**CIVIL ENGINEERING DEVELOPMENT APPLICATION REPORT
RESPONSE TO SARA RFI**

SARA reference no: 2602-50776 SRA
Council reference no: CA 2025_5878/1

PROPOSED RESORT DEVELOPMENT

18 OASIS DRIVE, WONGA BEACH, QUEENSLAND

Title:
 Bus Turning Circles
 14.5 m Rigid Bus
 Level 1 Reception

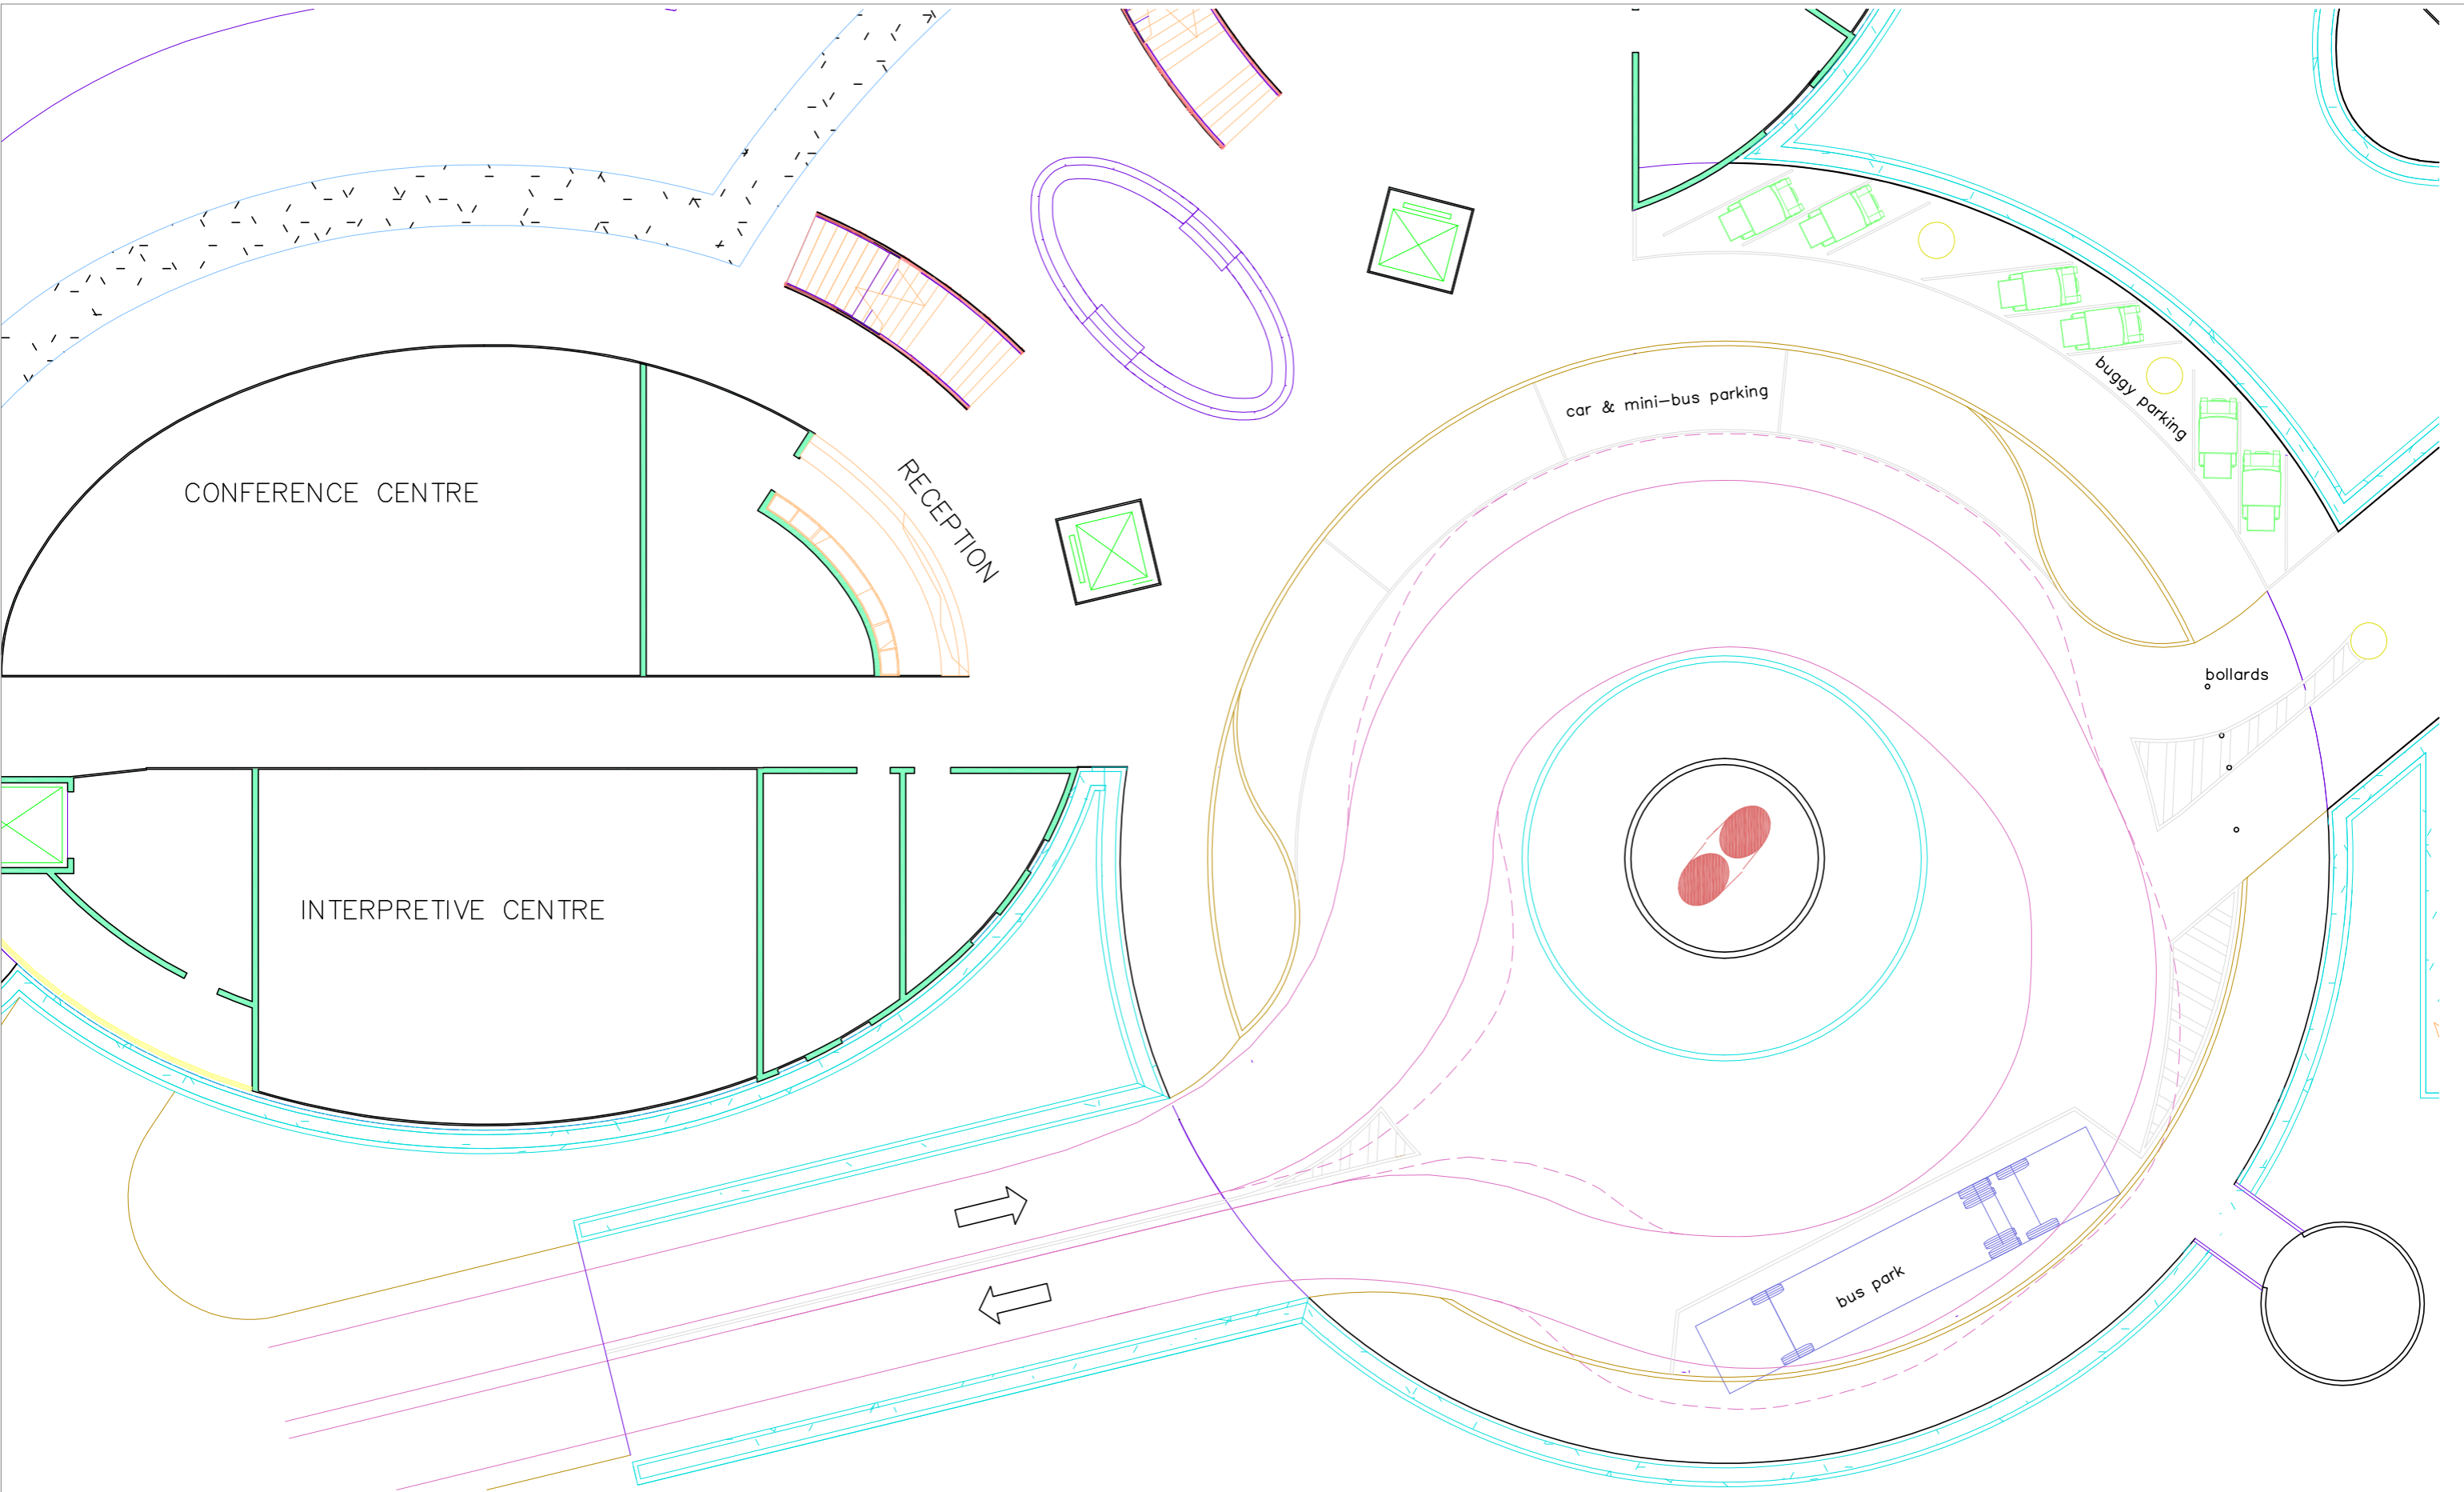
3. **Public Passenger transport – private bus set-down:**

Rigid 14.5 m buses are catered for on both levels in the Central building. The primary drop-off or collection point is beside the main reception on level 1. A dedicated bus park is provided for at this level. See drawing TC02. There is another bus park for a 14.5 m rigid bus at the Undercroft (ground) level. See drawing TC01. This is directly under the reception foyer, with two stairs and a lifts linking the levels.

Circulation is adequate at both levels. See the attached drawing TC01 & TC02 in appendix C. Both of these allow for smaller vehicle movement past a parked bus.
